Subject: Application for Amendment to Facility Operating License
Credit for Soluble Boron in Spent Fuel Pool
Rochester Gas and Electric Corporation
R.E. Ginna Nuclear Power Plant
Docket No. 50-244

The enclosed License Amendment Request (LAR) proposes to revise the Ginna Station Improved Technical Specifications (ITS) associated with the Spent Fuel Pool (SFP) Storage (LCO 3.7.13) and Design Features Fuel Storage (4.3).

**APPLICATION FOR AMENDMENT
TO OPERATING LICENSE**

Attachment I
R.E. Ginna Nuclear Power Plant

Figure 3.7.13-1
Fuel Assembly Burnup Limits in Region 1

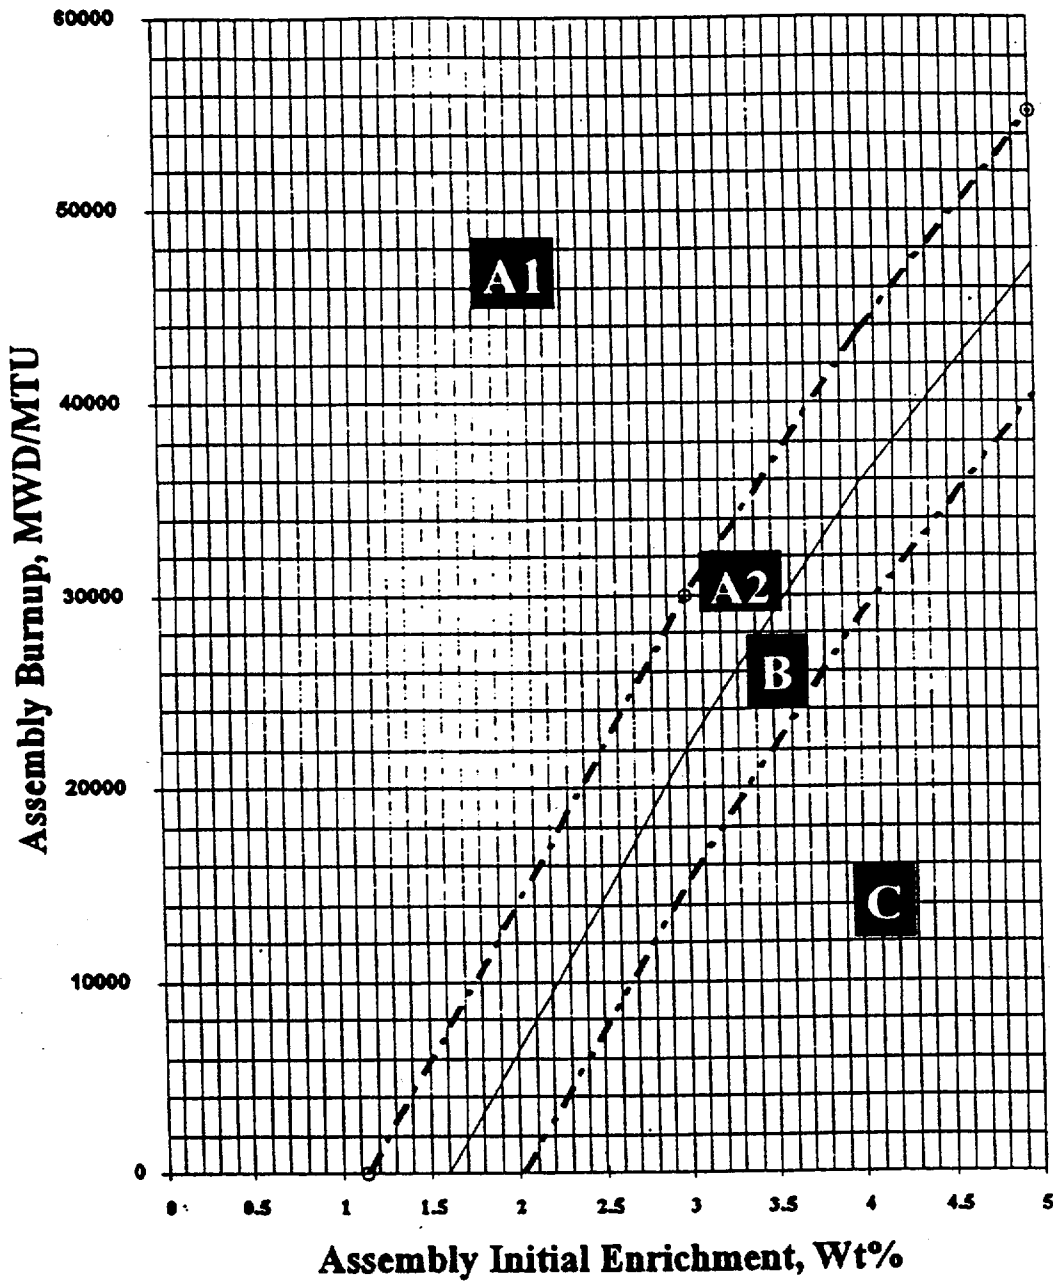
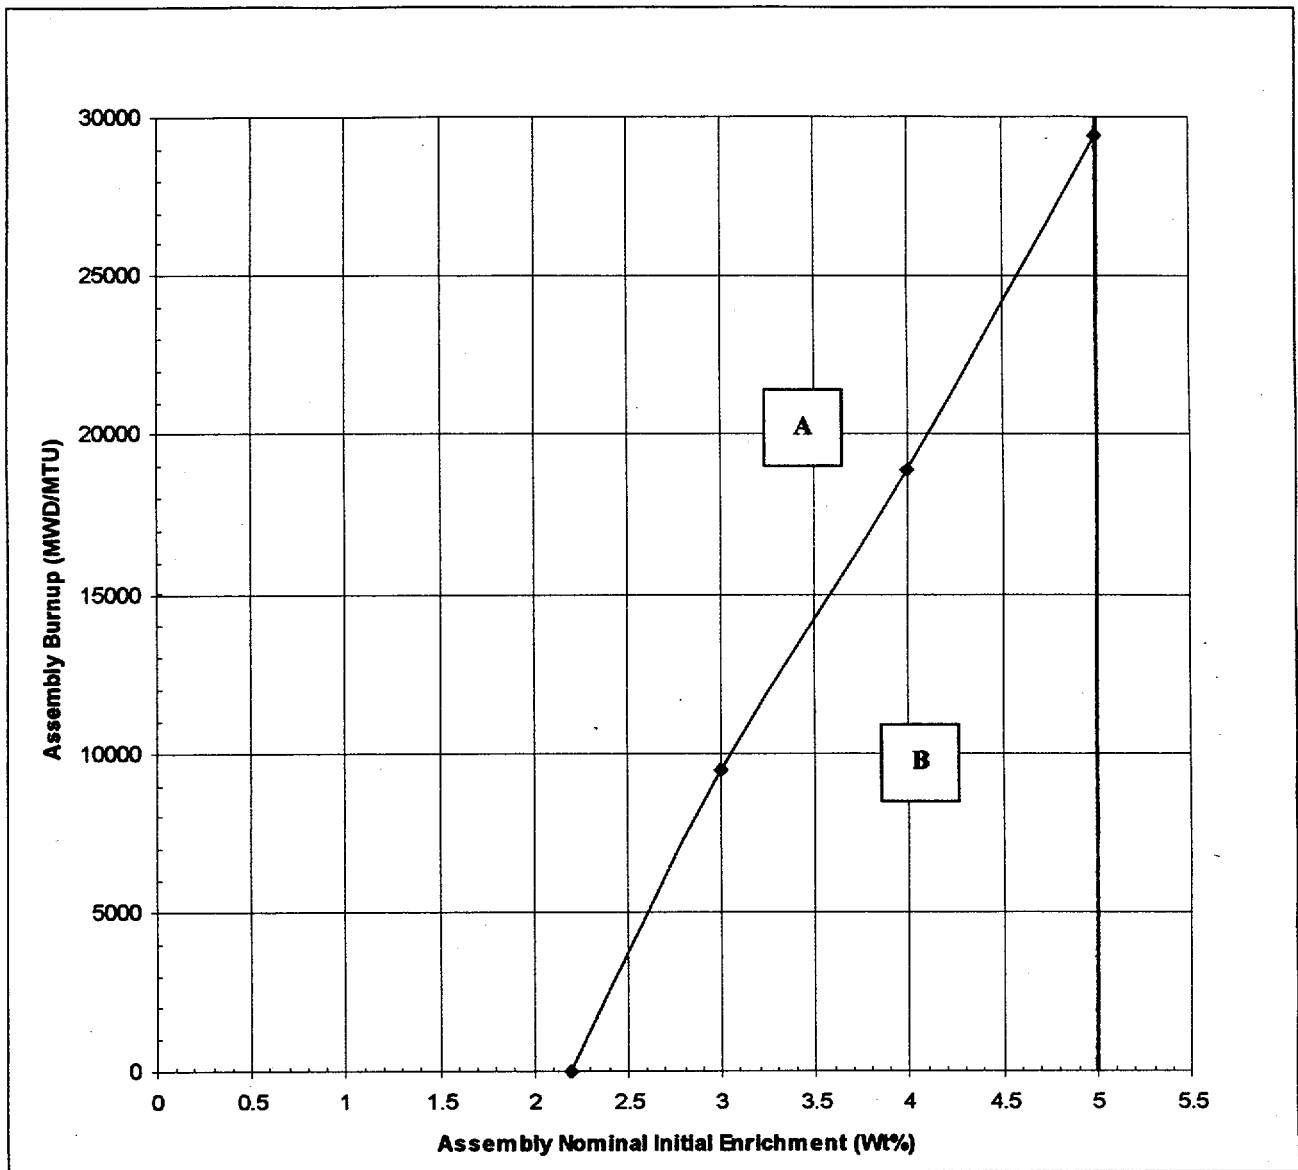
4. Surveillance SR 3.7.13.2 is being deleted, as it has been incorporated into SR 3.7.13.1.
5. Figure 3.7.13-1 which provides the initial nominal enrichment and burnup restrictions for storage in specified locations in Region 1 is revised to incorporate a new figure. There are no technical changes to the figure.
6. Previous Figure 3.7.13-2 which provided restrictions on acceptable storage locations for Region 2 based on initial nominal enrichment and burnup has been replaced by new Figures 3.7.13-2 through 3.7.13-11. The new figures provide restrictions based on initial nominal enrichment, burnup, decay time, and storage cell type.

- a. Fuel assemblies in Region 1 shall have a K-infinity of ≤ 1.458 and shall have initial enrichment and burnup within the acceptable area of Figure 3.7.13-1; and
- b. Fuel assemblies in Region 2 shall have initial enrichment and burnup within the acceptable area of the Figure 3.7.13-2.
